## KILDARE COUNTY COUNCIL

### PLANNING DEPARTMENT

| Type of Development:    | Residential- 74 no houses   |

| <b>Ref. No.</b>                 | P8 2017-005   |

**Figure 3 - Site Layout Plan**

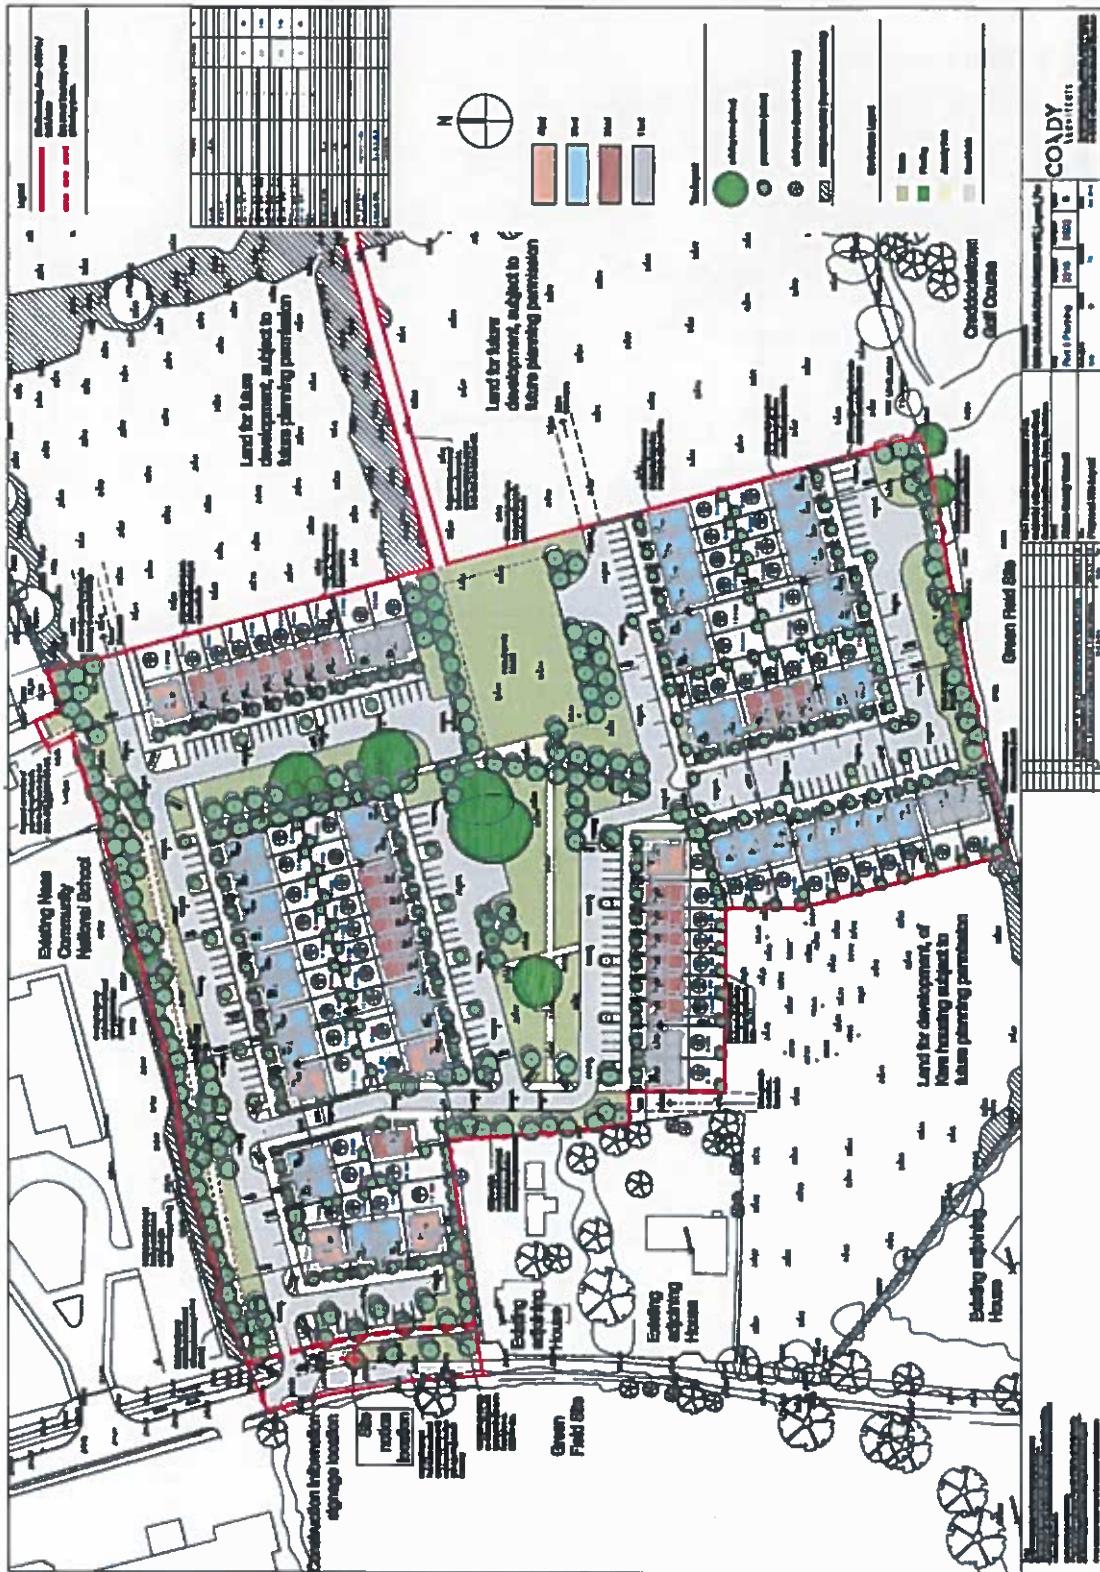
A total of 148 on street car parking spaces are proposed which is at a rate of 2 parking spaces per dwelling. The Transportation Section of Kildare County Council has requested that additional visitor parking spaces are provided at a rate of 10%. The additional visitor parking spaces will be provided in the development.

2m rendered block work wall with brick work piers every 2m. This boundary shall also benefit from supplementary planting. A 2m high railing is proposed in areas around the perimeter of the site, in particular on the eastern boundary, where the site connects to the adjoining land and these areas could provide for future linkages and connectivity to adjoining residential development. It appears that the boundary treatments are in accordance with development plan requirements.

It is stated that the access strategy for the site has been influenced and designed in accordance with the requirements of the Design Manual for Urban Roads and Streets (DMURS). Access to the development is from Craddockstown Road fronting the site to the west. It is proposed to extend the existing footpath and cycle arrangement from the front of the adjoining post primary school to the location of the proposed site entrance. A Traffic & Transportation Assessment has been prepared by Malone O' Regan Engineers and forms part of the plans and particulars supporting the proposed development. Indeed it is noted that the Craddockstown Road is identified in Table 6.1 of the Kildare County Development Plan as a Priority Roads & Bridge Project. Furthermore, it is noted that there are specific policies to realign and widen roads at a number of locations including the Craddockstown Road.

The primary access road runs along the northern boundary of the site and is strategically designed to accommodate future potential residential development on lands to the east.

- 1) The proposed development shall be carried out in accordance with the plans and particulars placed on public display on 11<sup>th</sup> April 2017, except where altered or amended by the following modifications.

- 2) All dwelling units shall be provided with the minimum storage requirements set out in the Kildare County Development Plan 2017-2023 or as agreed with the Planning Department.

- 3) The proposed development shall not impair existing land or road drainage.
- 4) Final details regarding pedestrian facilities, public lighting, car parking, lighting etc as raised by the Municipal District Engineer and the Transportation Department in their Reports and responded to by the Housing Department in its report on submissions and included as Appendix 2 of this Report shall be agreed prior to commencement of development.

- 5) A minimum of 1,000 litres/min of water shall be available in the mains at 2 bar pressure for fire fighting purposes.
- 6) Final details regarding the requirements of the Council's Environment Department, Fire Service and Water Services Departments and of Irish Water as identified in their submissions and responded to by the Housing Department its report on submissions and included as Appendix 2 of this Report shall be agreed prior to commencement of development.

- 7) All measures necessary shall be taken to ensure comprehensive protection of local aquatic ecological integrity. This shall be appropriately addressed by the incorporation of the relevant issues/comments/recommendations raised by Inland Fisheries Ireland

- 8) All metal boundary railings shall be powder coated.
- 9) In the interests of residential amenity the hours of construction activities on the site shall be restricted from Monday to Friday 08.00 - 18.00, Saturday 08.00 - 13.00 or as agreed with the Planning Department. No building activity shall be undertaken on Sundays and Bank Holidays under any circumstances.
- 10) Final details regarding the proposed boundary walls and entrance adjoining the neighbouring property, waste water and stone piers as raised in Third Party submission received on 12<sup>th</sup> June 2017 shall be reviewed and discussed with the Third Party. Final details shall be agreed with the Planning Department.
